ITEM: VILLAGE OF DOWNERS GROVE PARKING FACILITY
PROJECT #14-00

PURPOSE: To authorize execution of contract Change Orders #8, 9, 10, & 11 for the Village of Downers Grove Parking Facility, Project #14-00

Change Order No. 008 *DRAFT*

Change Order No. 009 *DRAFT*

SK-042004E 2/5

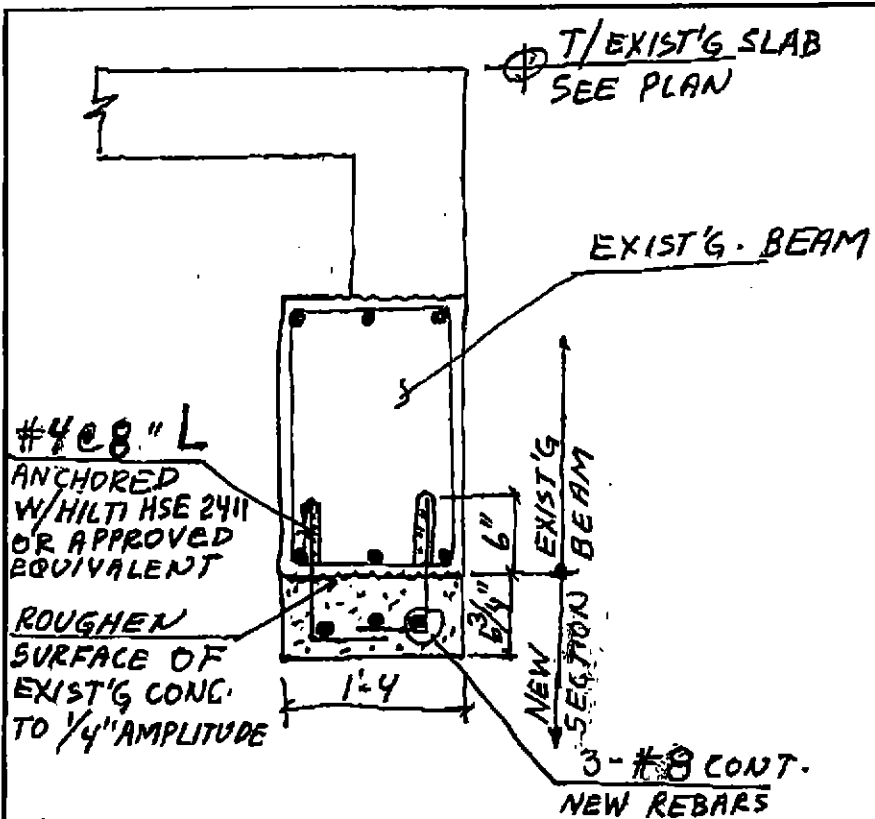
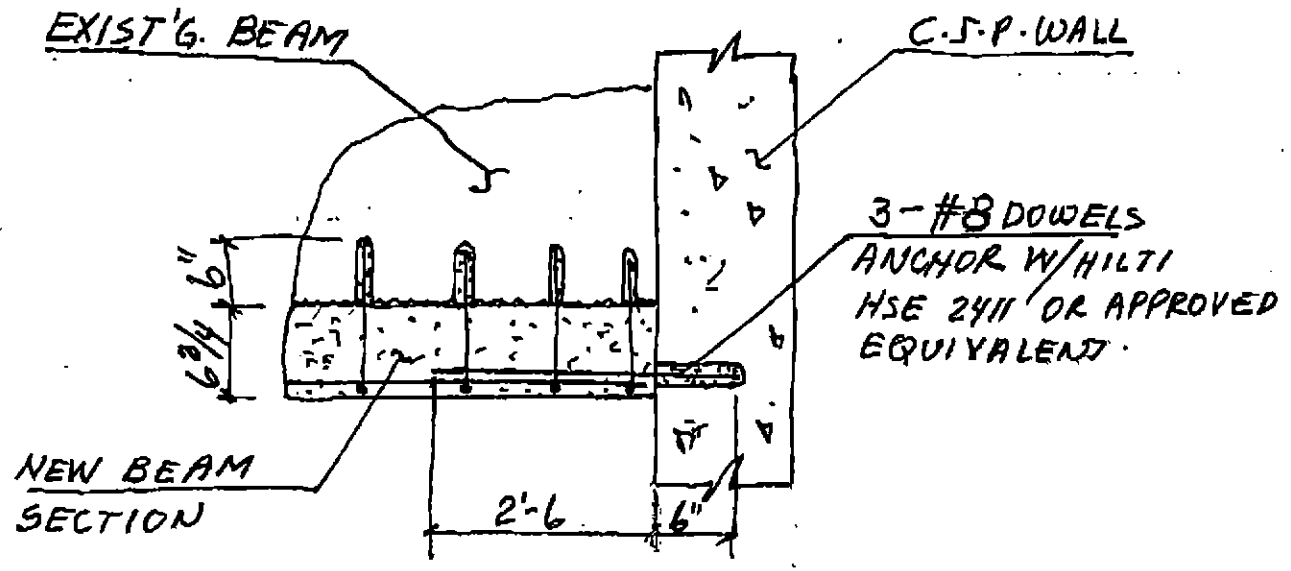
1. On Stair Tower No. 1, remove existing intermediate landing and supporting beam mark B12 (elev. 12.26) and re-construct new intermediate landing & beam at elev. 11.70. This entails provision of additional riser from new intermediate landing at elev. 11.70 to existing second level at elev. 15.08. It also eliminates one riser and lengthen intermediate landing from elev. 6.62 to the new intermediate landing at elev. 11.70 as shown on photo 042004 and sketches SK-042004A, SK-042004B & SK-042004C.

SK-042004 G

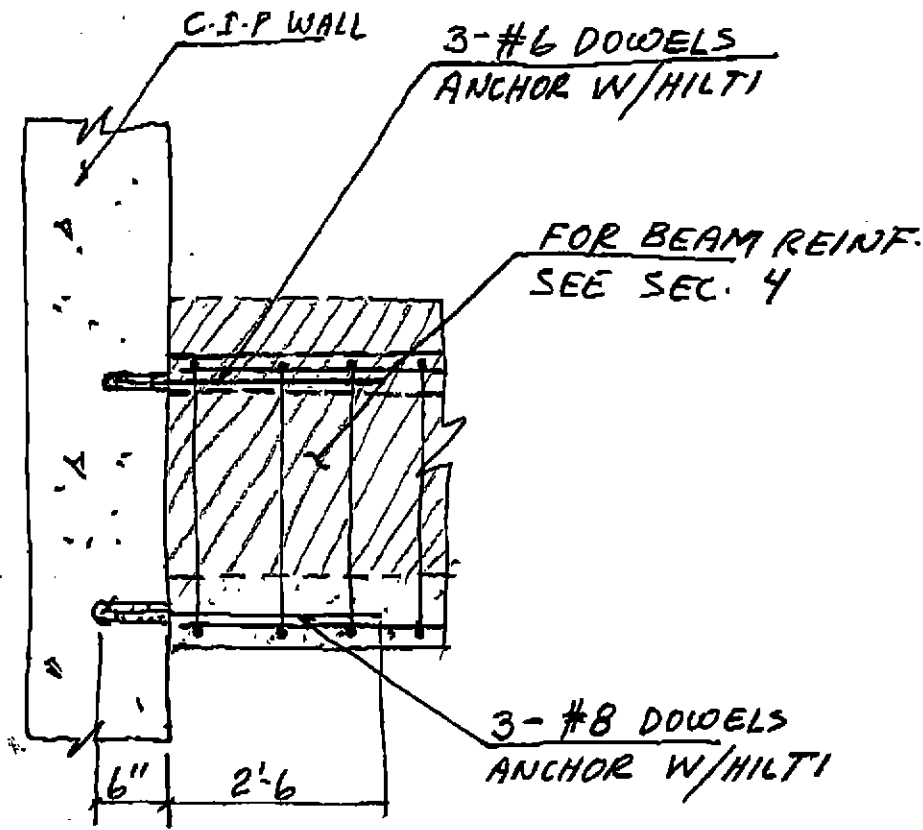
4. Refer to sketch photo 042004 and SK-042004G to reconstruct new stair landing at new elev. 11.70.
